SERVICE BULLETIN

APPLICABILITY: 2013-2019MY BRZ

NUMBER: 12-267-19

SUBJECT: Front Bumper Cover Gap / Loose Fit

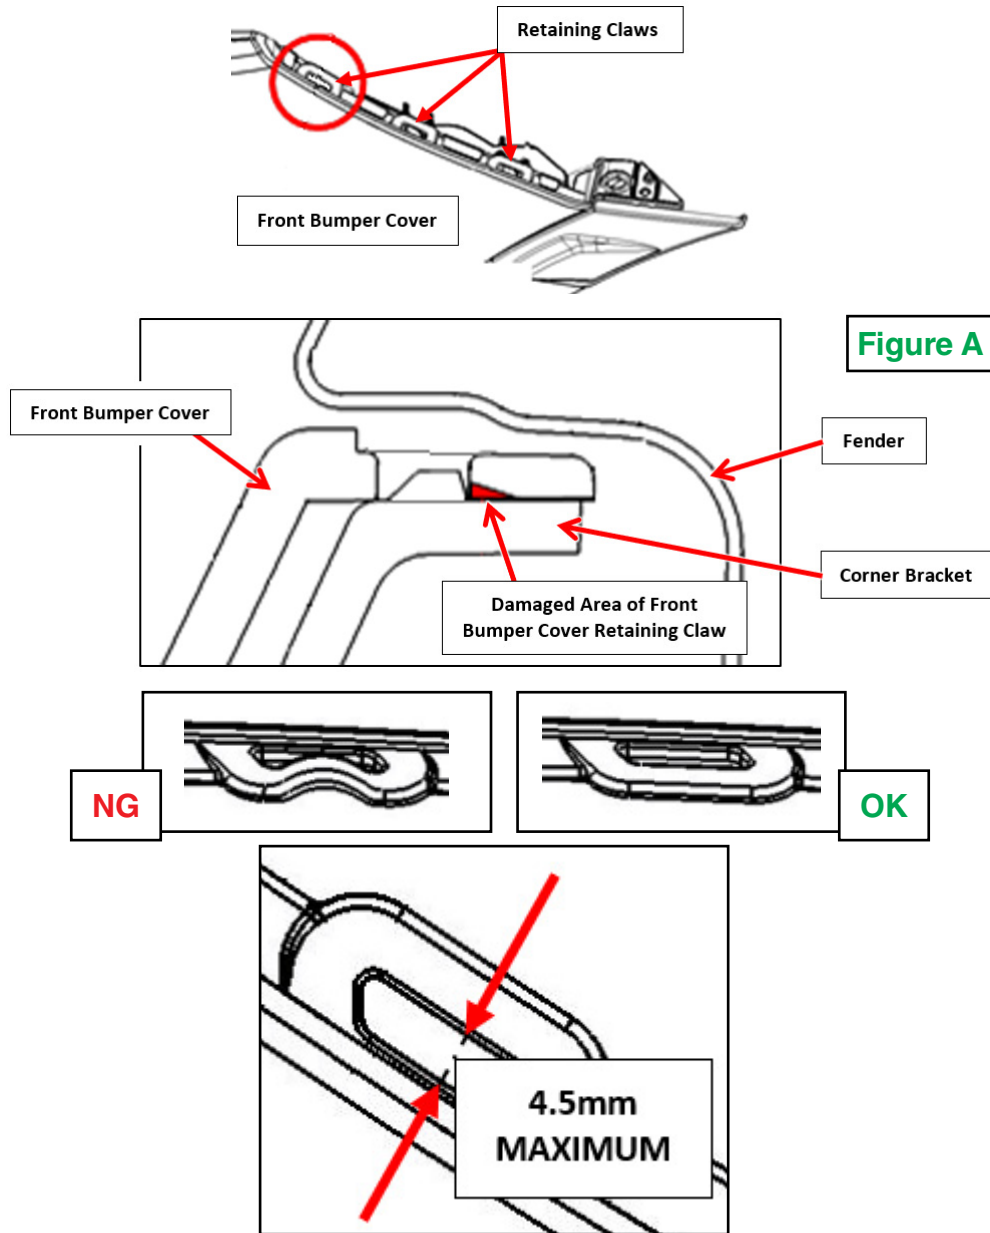
- 1) After confirming a loose fit / excess gap condition exists, CAREFULLY remove the front bumper cover assembly following the procedure in the applicable Service Manual. Follow all precautions to protect the finish of both the cover, fender and surrounding painted surfaces.
- 2) On each side of the bumper cover, there are 3 claws to secure it to the corner bracket as shown in the illustrations below. These claws can become damaged reducing their ability to secure the cover to the corner bracket properly. This causes the gap / loose fit condition to occur.

- 3) Inspect the removed bumper cover and determine if it is reusable by the following criteria:
 - If any of the claws are broken, deformed as shown in the **NG** illustration above or, have a center opening exceeding 4.5mm, the cover must be replaced following the procedure in the applicable Service Manual.
 - If the claws are in-tact as in the **OK** illustration and / or only have minor wear as shown in **Figure A**, proceed to **Step 4** below.

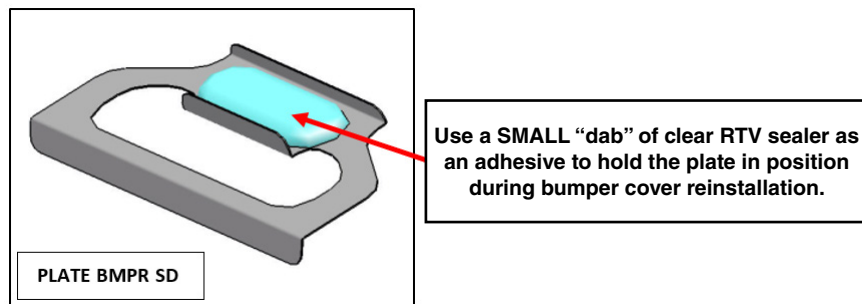
- 4) Remove any dirt or grease from the affected claws using a mild solvent on a clean shop cloth and thoroughly dry.
- 5) Inspect the claws closely. CAREFULLY remove any burrs which could prevent the new plate from fitting properly as shown in 7) below using a small flat file or sandpaper.
- 6) Apply a VERY SMALL amount of clear RTV sealant to the new plate as shown below.

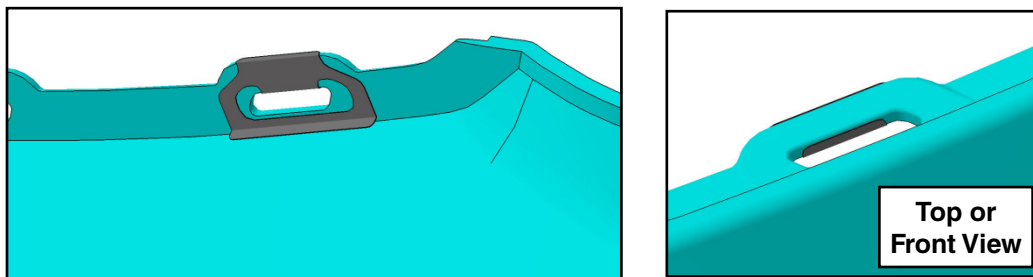
- 7) CAREFULLY install the new plate(s) as needed to the back (under or inside) of the affected claw(s) using the illustrations below as a guide for a proper fit. **CAUTION:** These plates have sharp edges.
